M/027/007 & M/023/013

JUMBO MINING COMPANY
DRUMMINE / ALTO-IBEX

OPERATOR RESPONSES &
DOGM TECHNICAL REVIEWS
(FEB/89 —)

Re: Technical Review of Notice of Intention to Commence Large Mining Operations, Drum Mountain Project, M/023/013, Juab County, Utah

Revisions in red, January, 1989 based on aerial contour map (1" to 100', flown 7/22/87) & ground measurements taken 1/89.

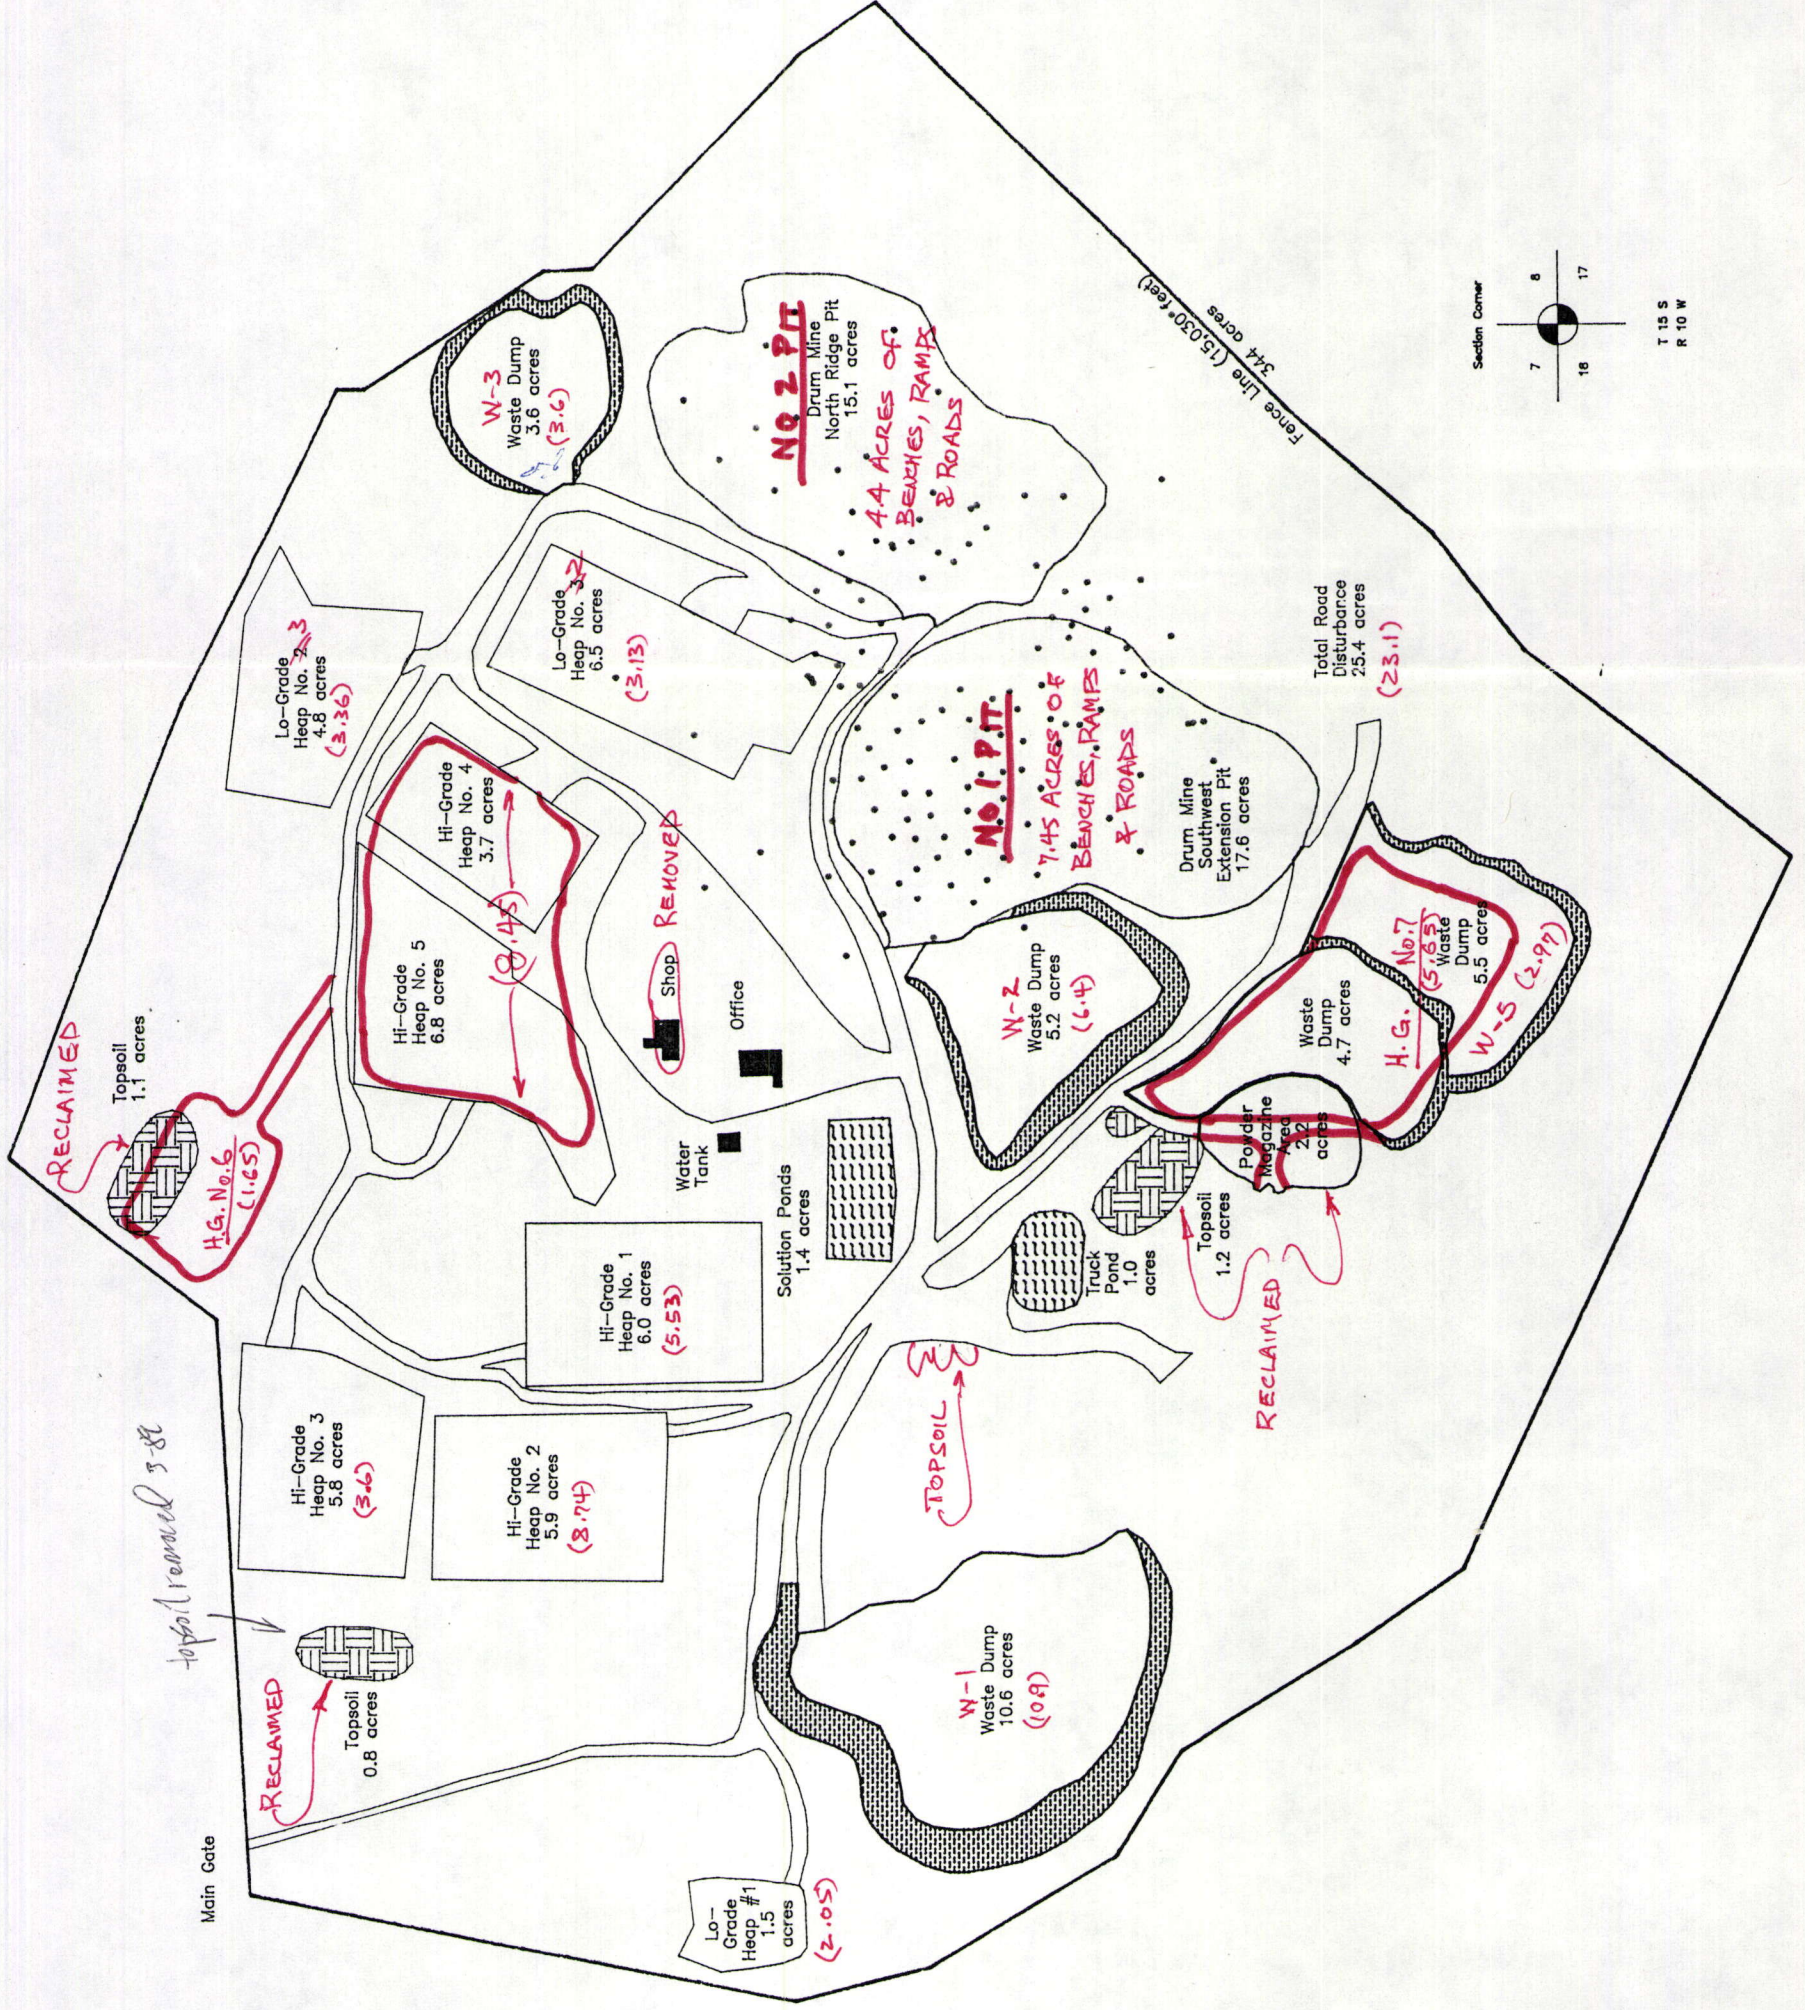
Revised areas in parentheses in acres.

Shop building (40' x 80') removed 11/88.
